HISTORIC PRESERVATION ADVISORY BOARD

Thursday, August 6, 2015 – 6:00 p.m.
Commissioners Hearing Room
Third Floor of the Boulder County Courthouse

BOULDER COUNTY HISTORIC PRESERVATION ADVISORY BOARD

MINUTES
June 25, 2015
6:00 PM
Caribou Room
Second Floor of the Land Use Department

SITE PLAN SCALE: 1" = 20'

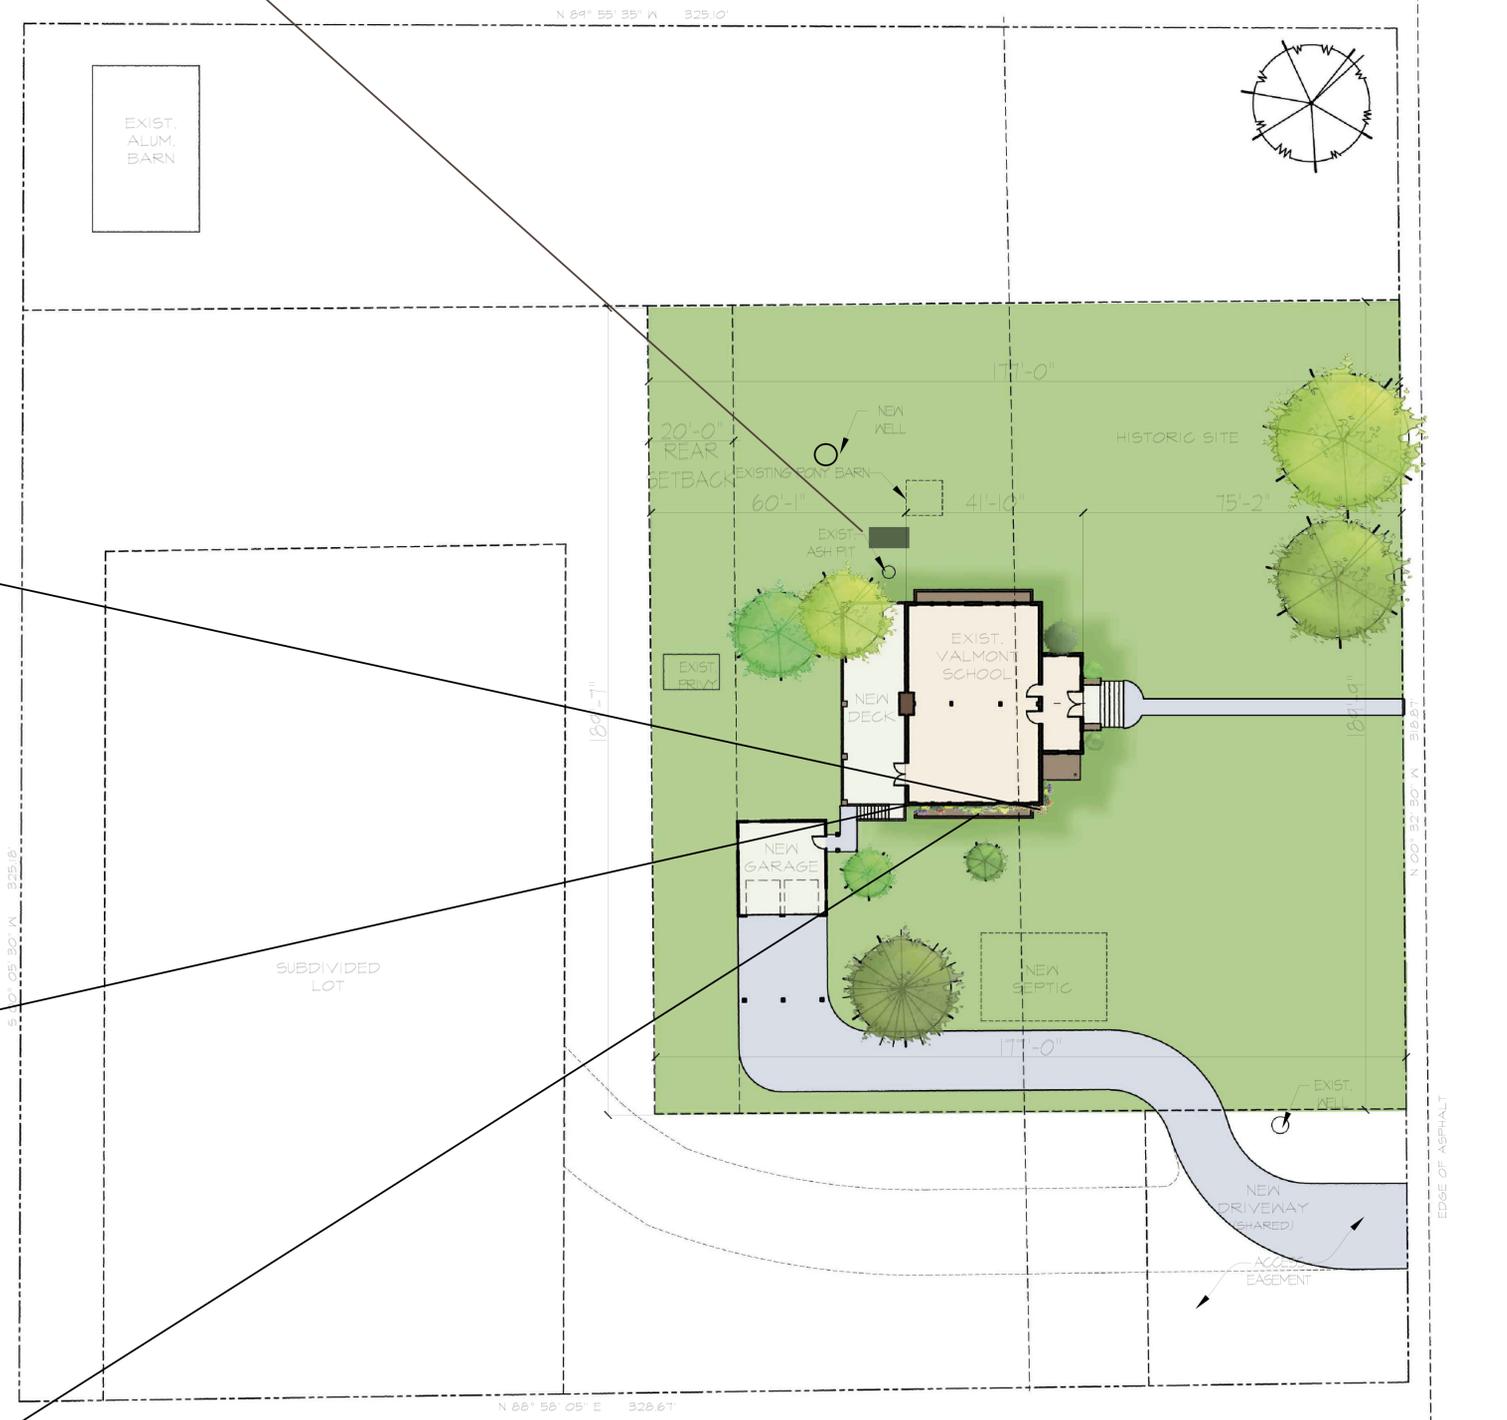
The locations for the privies and ash pit are shown but not the historic portion of the pony barn which was to be moved to the landmarked area. Before any more permits or approval for the property I think we need to establish what will happen with these accessory buildings and have a plan in place for their preservation.

They have also modified the garage as asked to turn it to the side and have added a larger carport to it, reduced the driveway paving and have extended the deck on the back to be the full width of the building.

The final front door details and rehabilitation plans for the pony barn and privies should be provided for review by a subcommittee. Any modifications to the grading or drainage would need to be approved by at least a subcommittee of HPAB or the full board if deemed necessary.

GRADING PLAN
 SCALE: 1" = 10'-0"

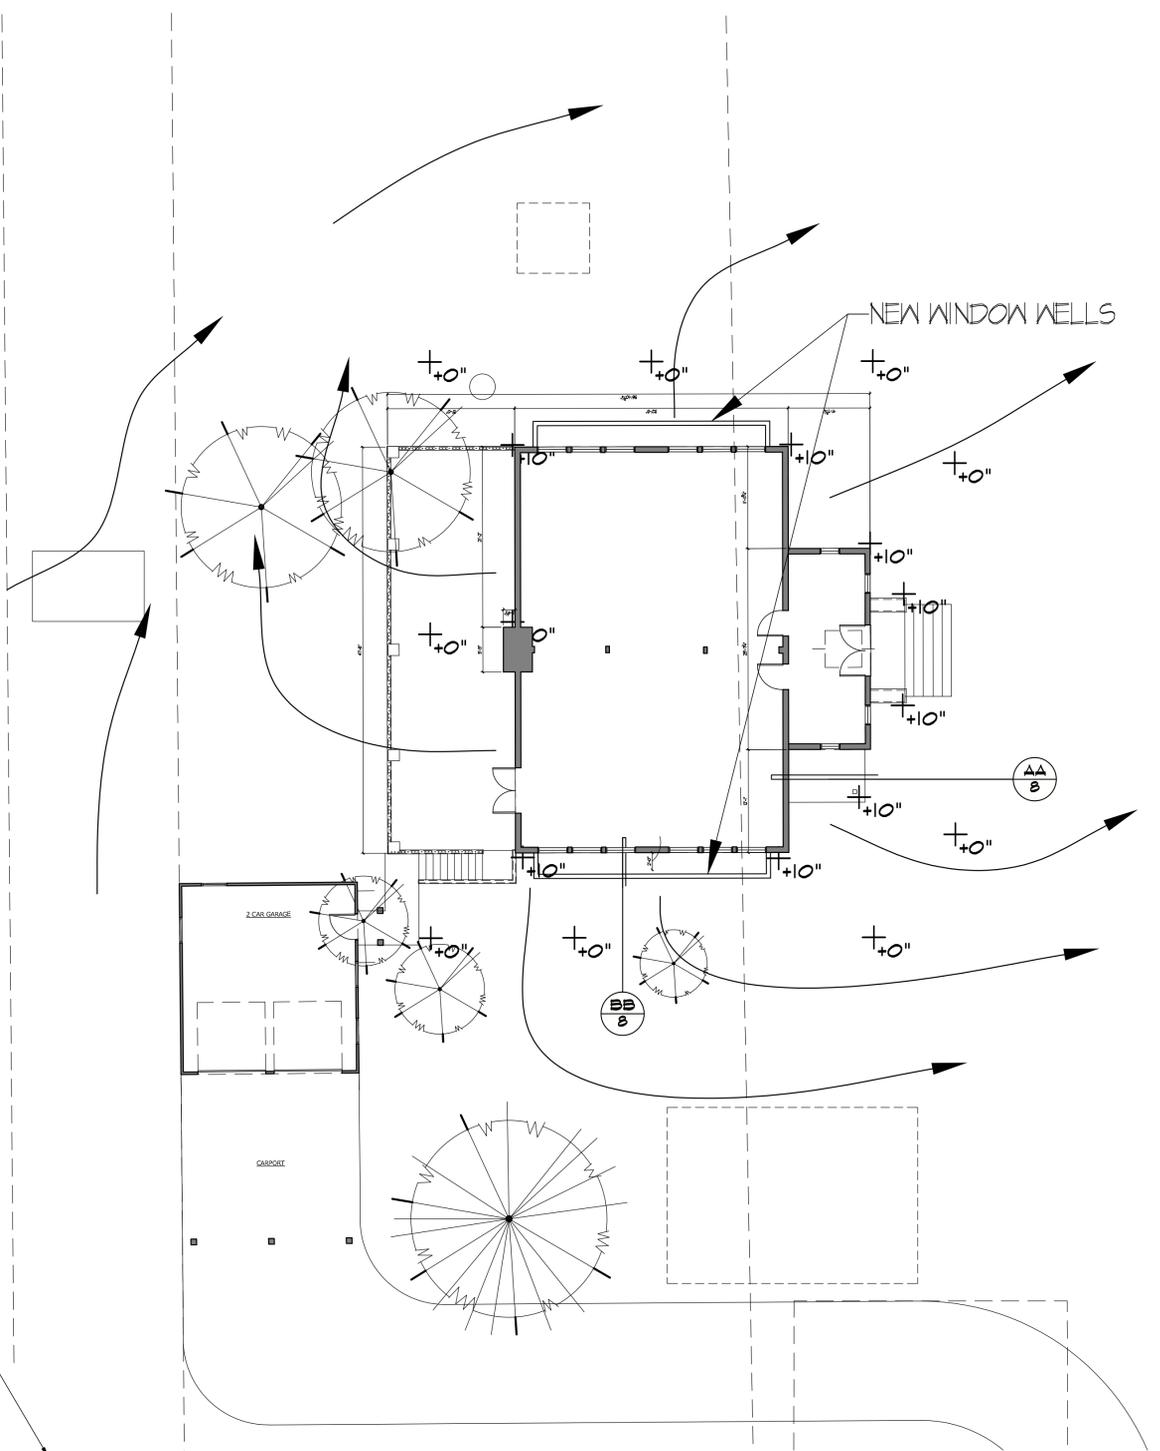
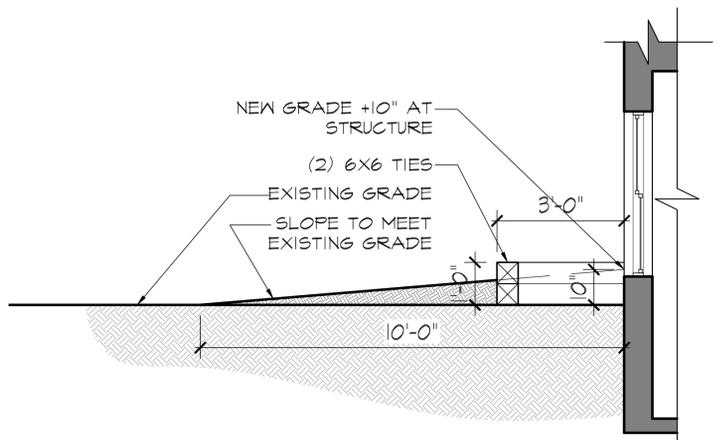
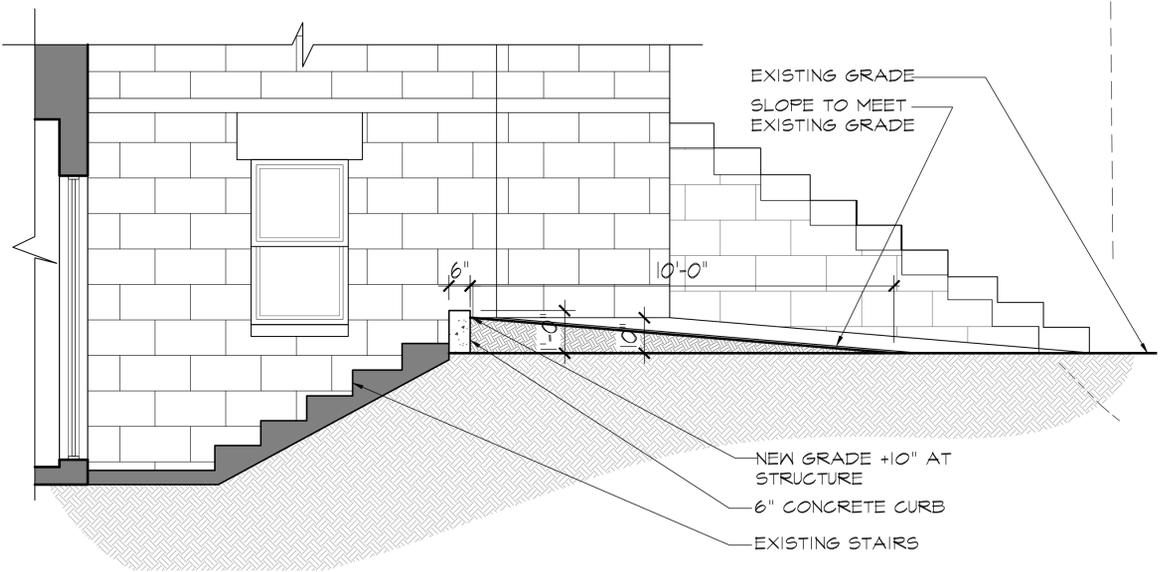
The owner and staff met to discuss floodplain and drainage issues. The owner is continuing to work on this. They do need to establish positive drainage around the building and staff asked that this be the minimum necessary. The owner is now proposing to add 10 inches of fill around the building to

1. Window and door wells, drainage and grading as shown being a maximum depth of 10 inches of fill and curbs a maximum of 12 inches above current grade;
2. The new garage orientation;
3. The new driveway configuration;
4. The new deck dimensions.
